May 9, 2022

**RE: Lot 25 Block 9 Unit 18, S.A.D. 228
Volcano Cliffs Subdivision
6511 Picardia Pl. NW
Grading and Drainage Plan
Engineers Stamp Date 3/9/2022
Pad Cert Date: 5/6/2022 (D10D003125)**

CANDELARIA HOMES -- STROMEI -- G & D PLAN

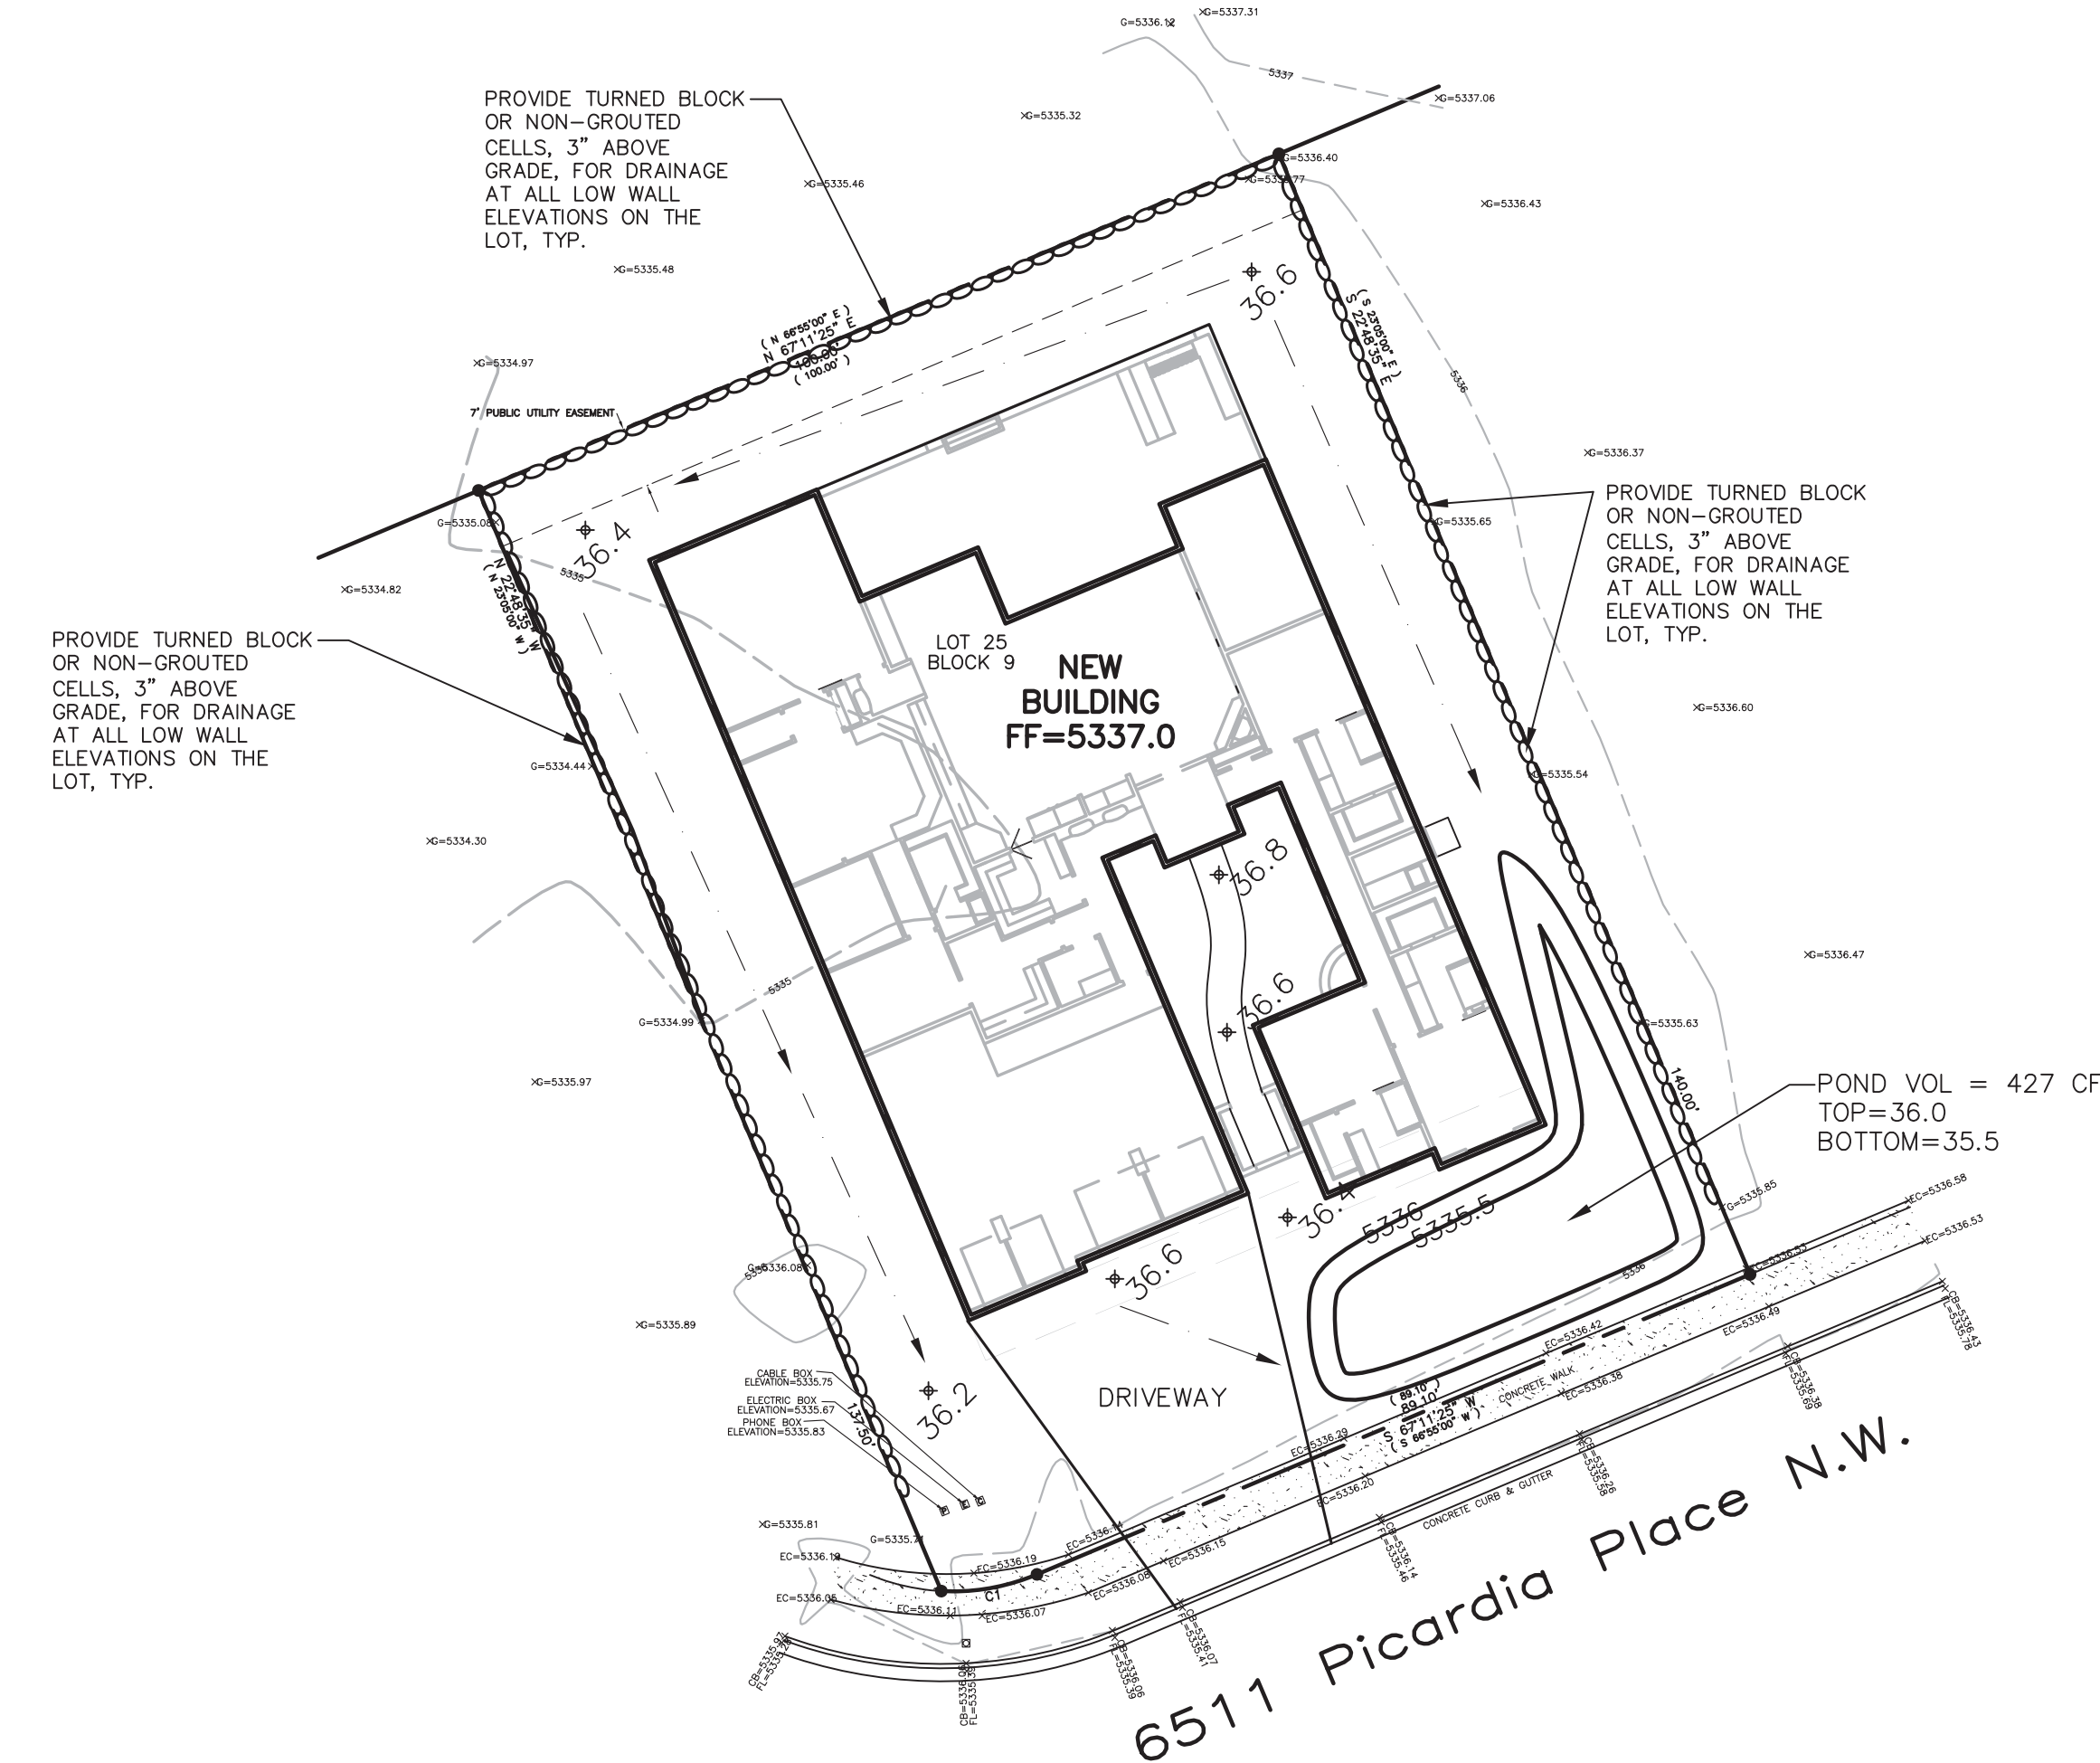
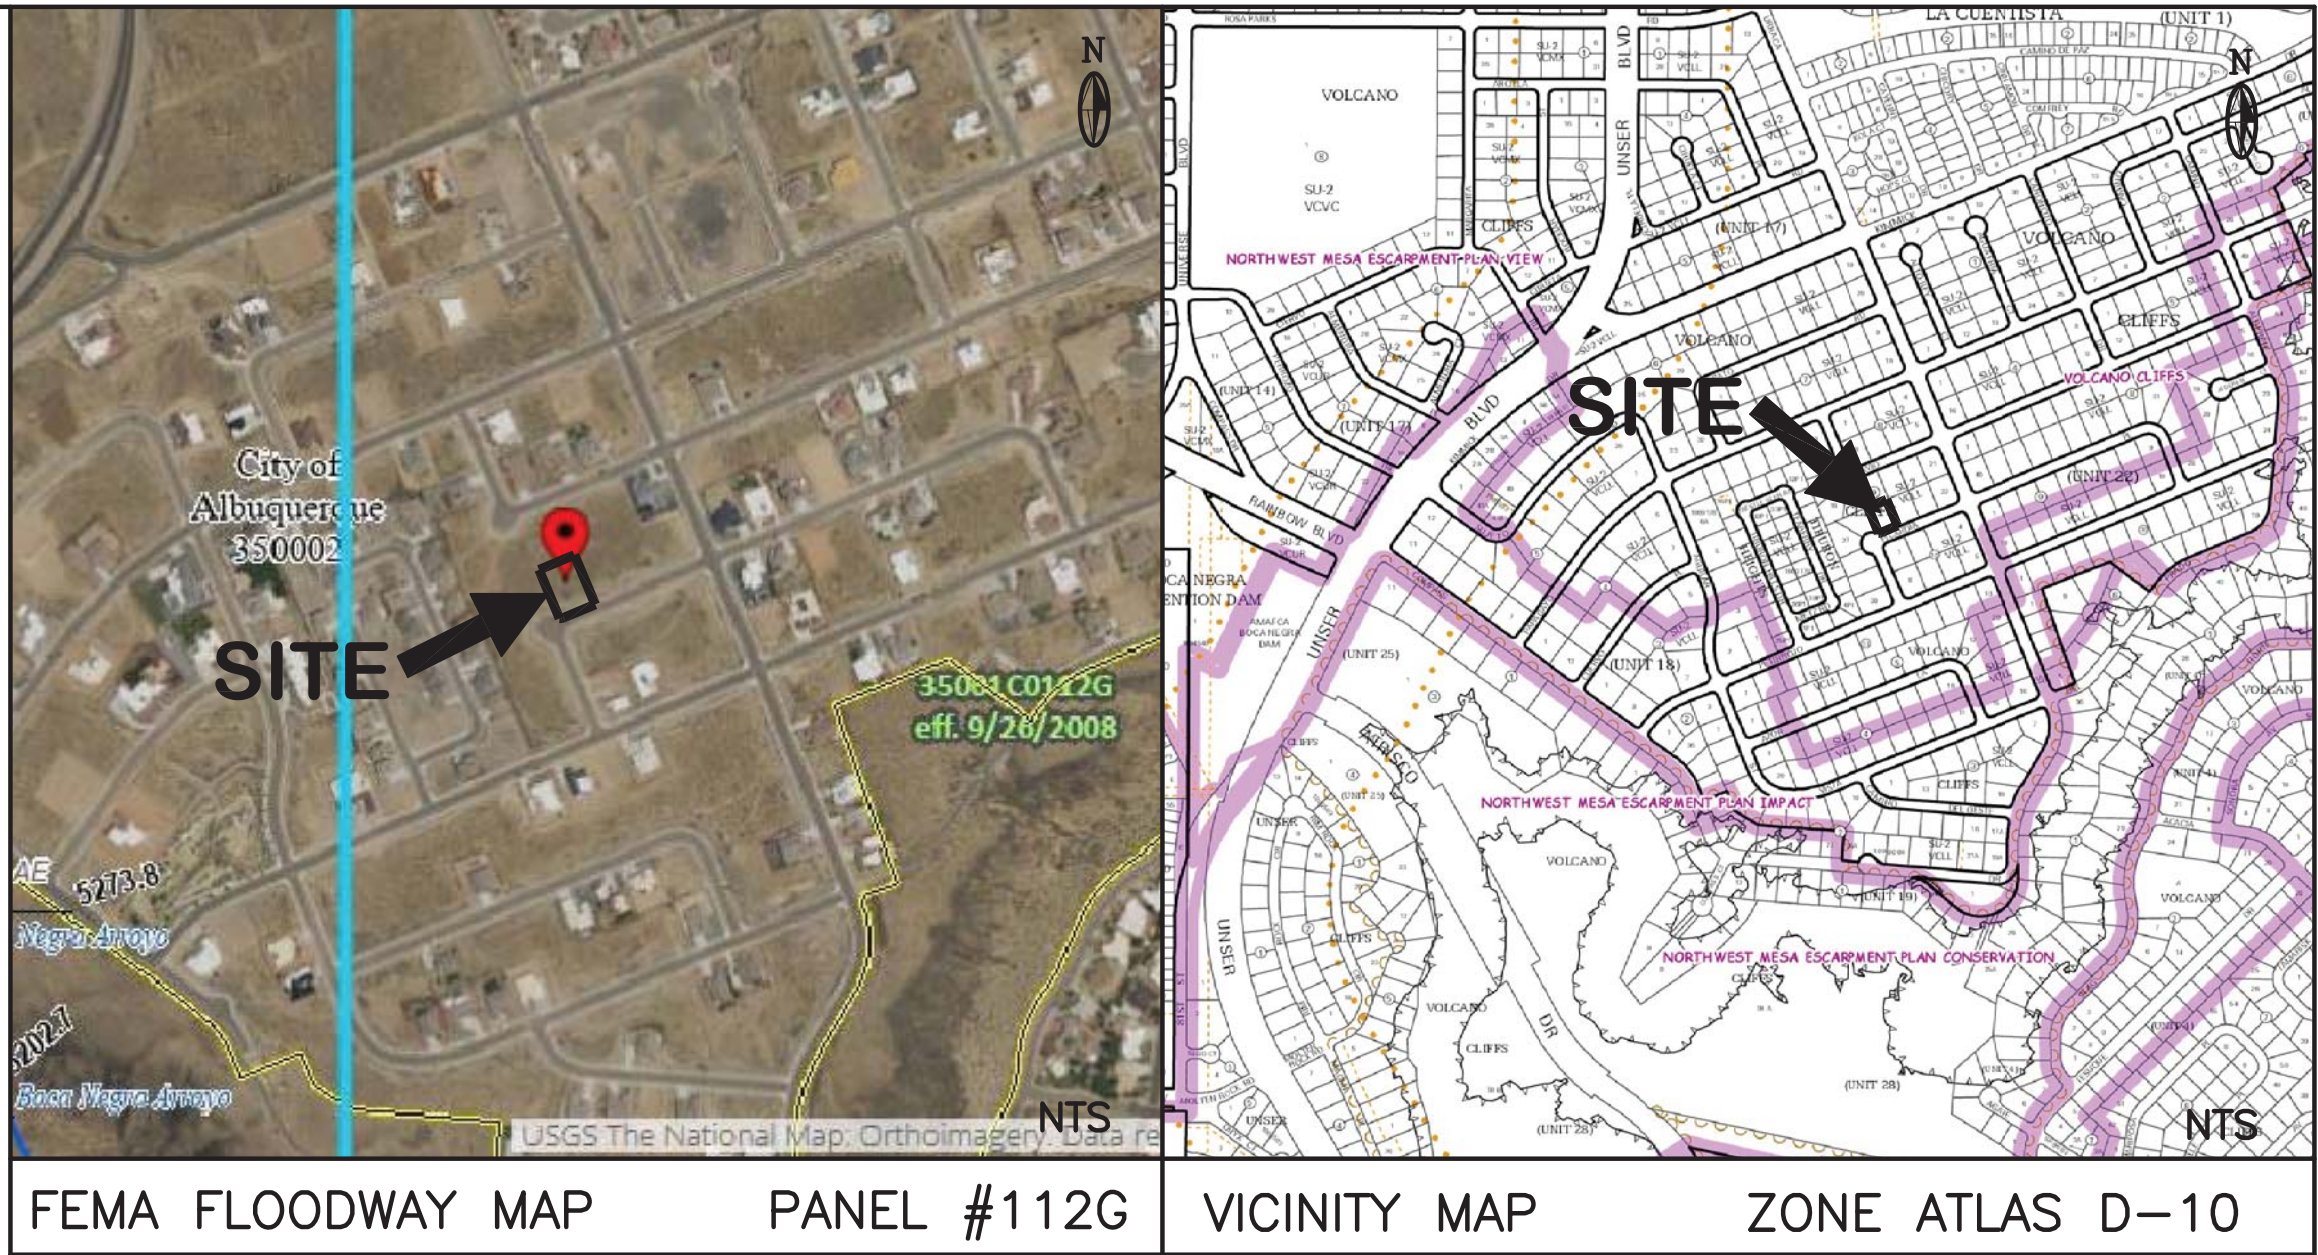
Reiterate to the Owner/Contractor that a separate permit for a garden/retaining wall must be obtained, with the approved G&D plan and Pad Certification. Also, let the owner/contractor know that if a pool is to be added in the future the G&D plan will need to be modified showing the location of the pool and the land treatment differences. Also advise the owner & Contractor that dirt is not allowed in the public right of way to climb the curb. Crusher fines or lumber is allowed. If dirt is used this will delay going forward with the construction of the home.

This is the plan to be used for any garden walls and any openings in the walls shall be placed 3" above final grade in the rear yard to allow for cross lot drainage from west to east (upstream to downstream).
